Product/Process Change Notice (PCN)

PCN #: WL-SWTP_20160718

Product Affected: WL-SWTP 158301xxx

1. Old Package Schematics

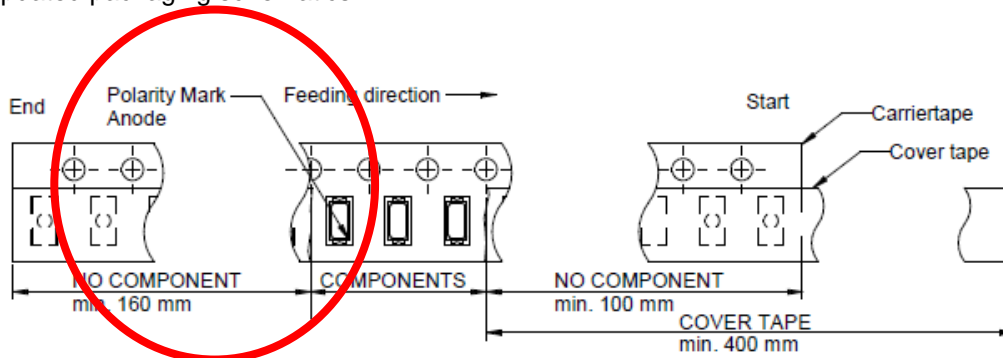
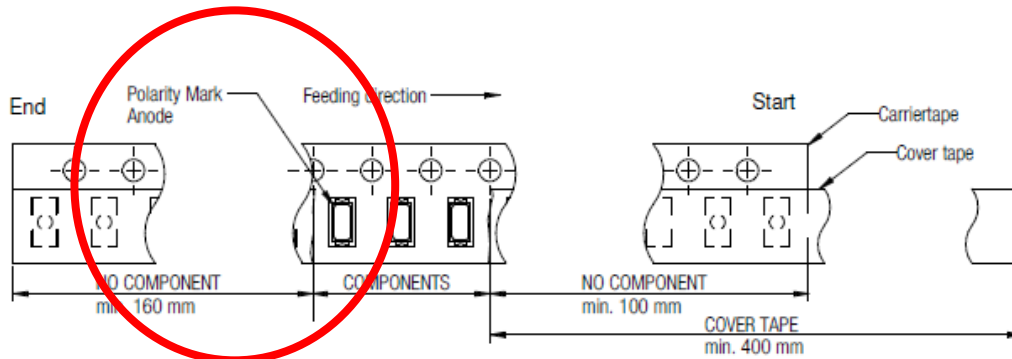
To follow the general market standard the LEDs in the package have been rotated 180° degrees.

The LEDs are packaged with the cathode facing the belt lead, compared to the old specification with anode top.

In relation with PCN# WL-SWTP_20160318 and because of a database mismatch, the packaging specification in the datasheet has been updated.
